Flood Control  
WATER PERMIT NO. FC-4

**Application For Permit To ~~Appropriate Water Within The State Of South Dakota~~**

BRANT LAKE SP-WAY IMPROVEMENT PROJECT

IN RE APPLICATION FOR FLOOD	)	FINDINGS OF FACT,
CONTROL PERMIT NO. 4	)	CONCLUSIONS OF LAW
	)	AND FINAL DECISION

(Figure 3)

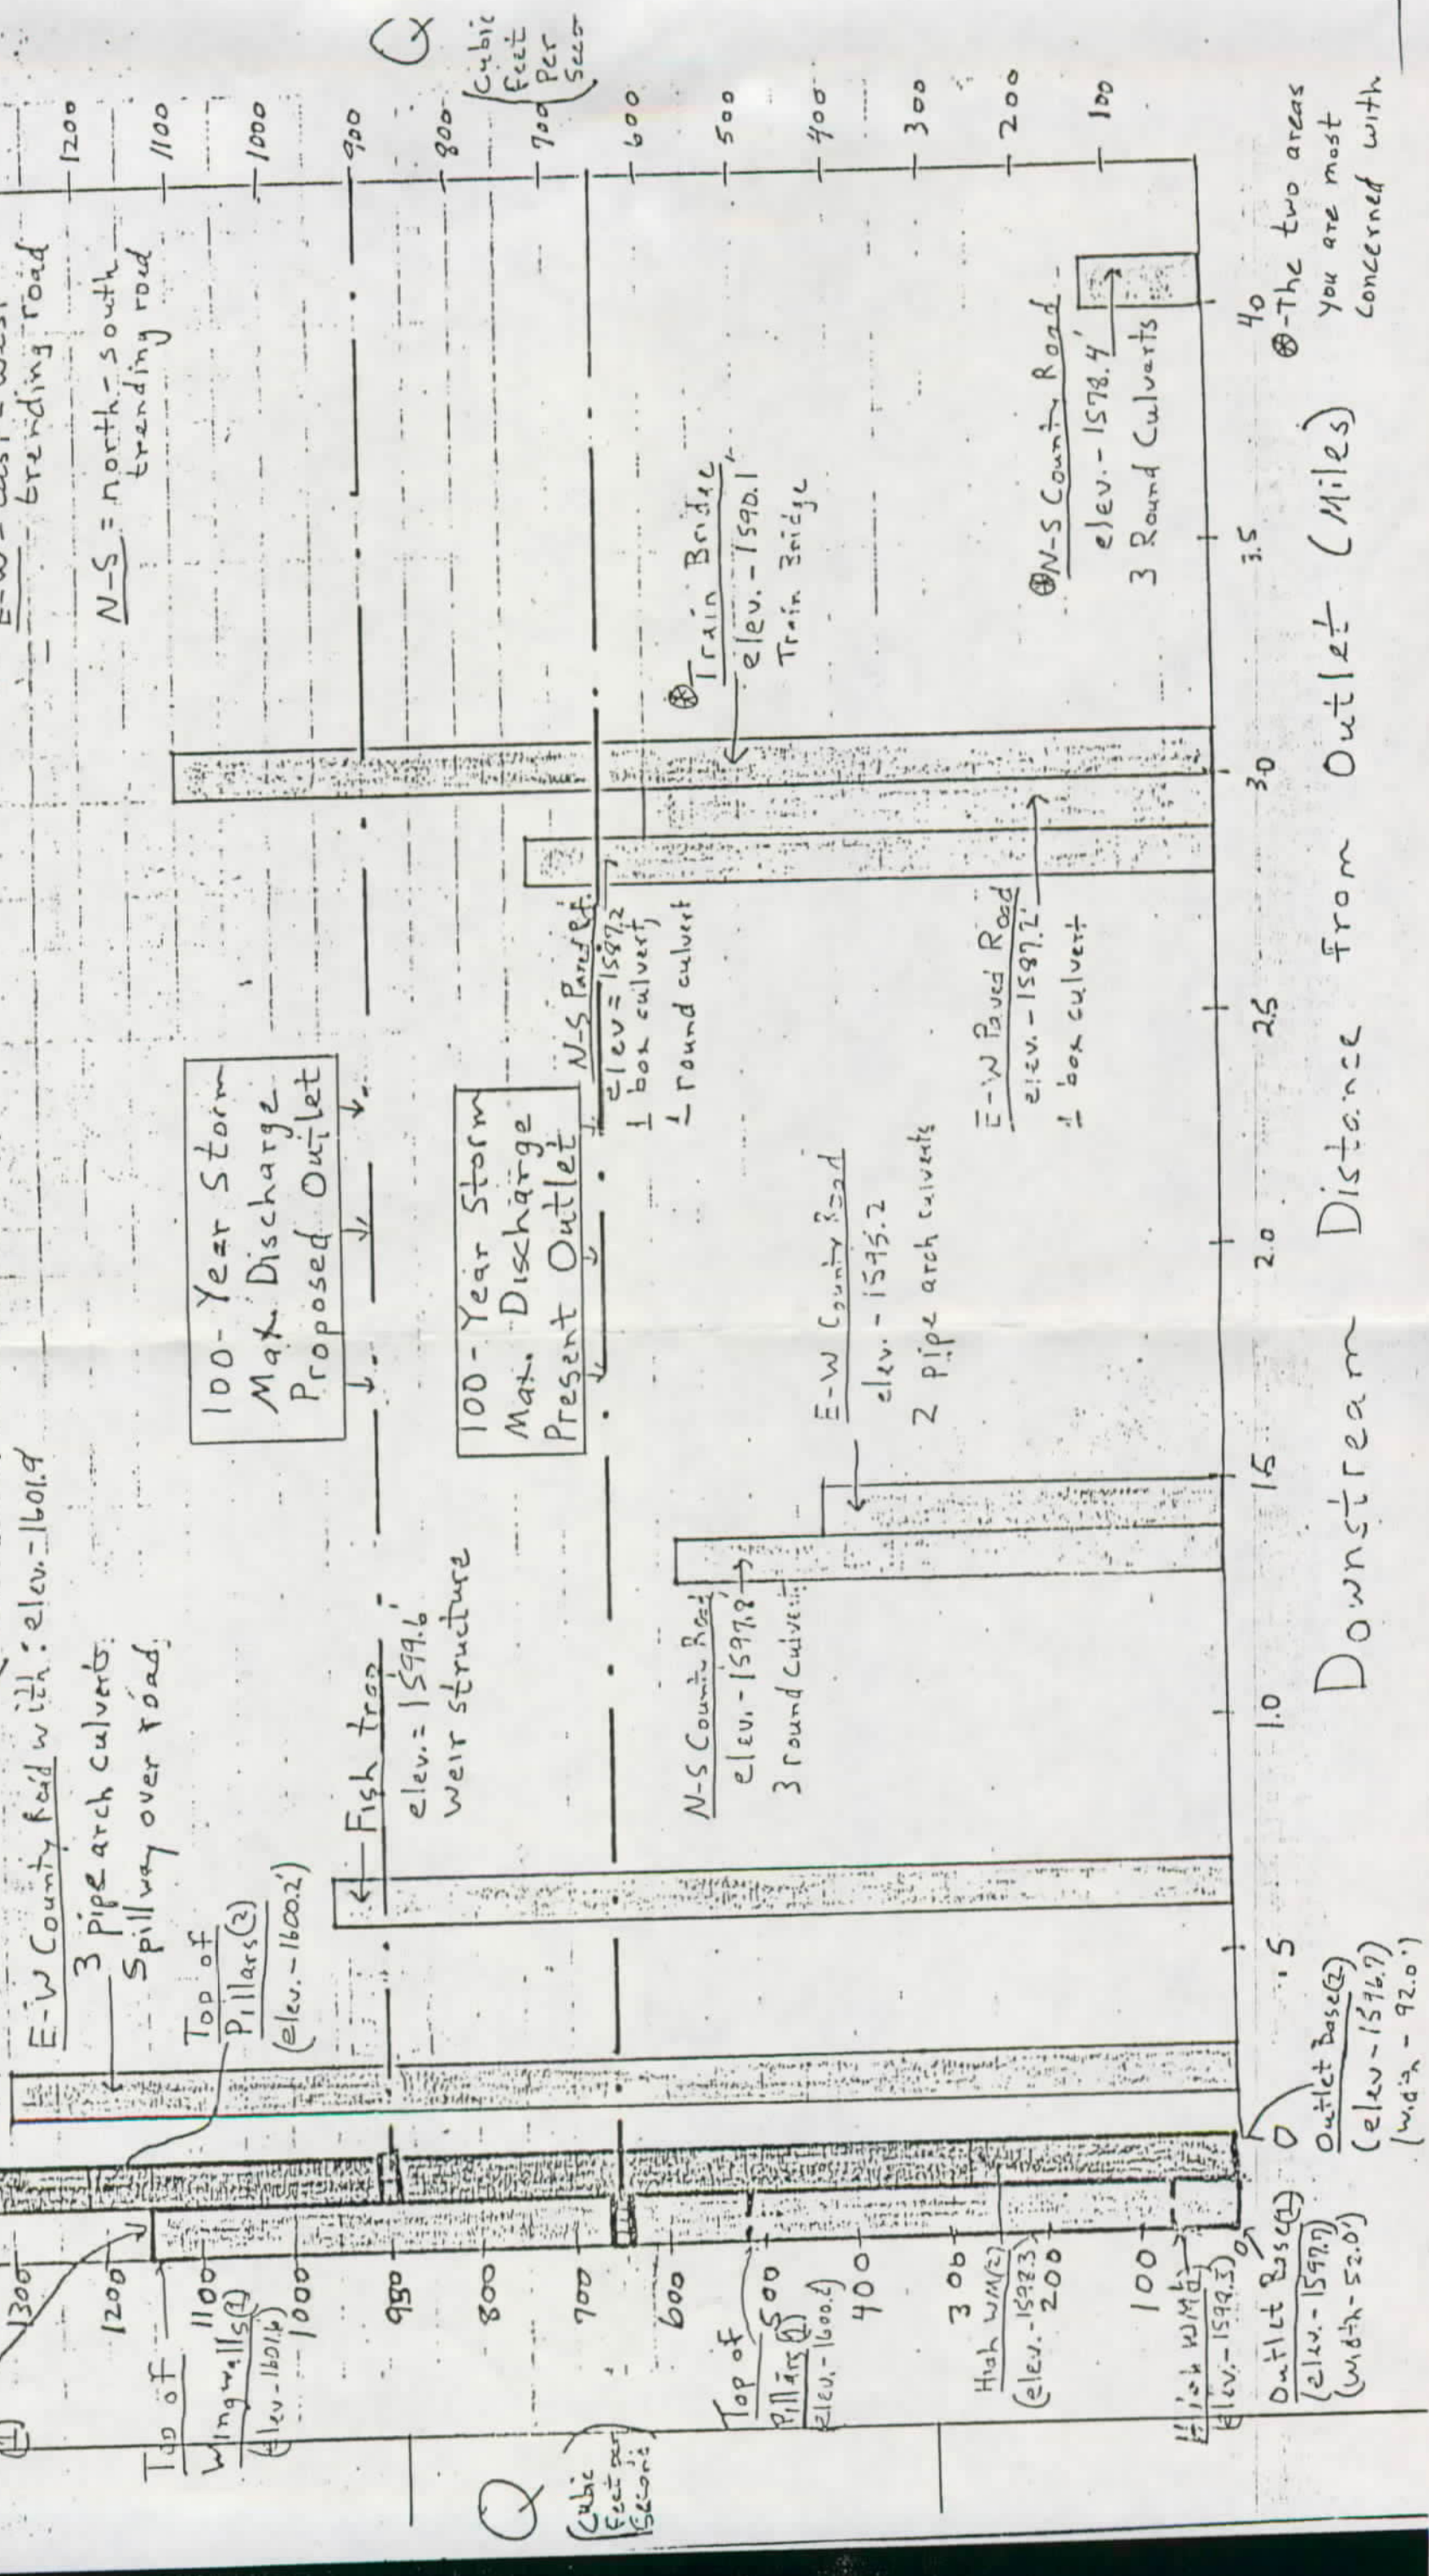
to reach these maximum head values is not considered. The results of this portion of the investigation are shown in Figure 3.

Q - The two areas you are most concerned with

Whether the road would overtop depends somewhat upon on the design of the new culverts. If the entire flow does pass under the E-W road culvert, the water may be temporarily "stacked up" in the dike area due to the channel restrictions noted in question 4. This could cause some impoundment there before flowing under the railroad bridge. Because the water elevation by the dike could get higher than by the E-W road culvert some water could temporarily flow back through the culvert. This would be short lived; once the peak has receded and the downstream gradient reestablished the water would flow unimpeded through the dike area.
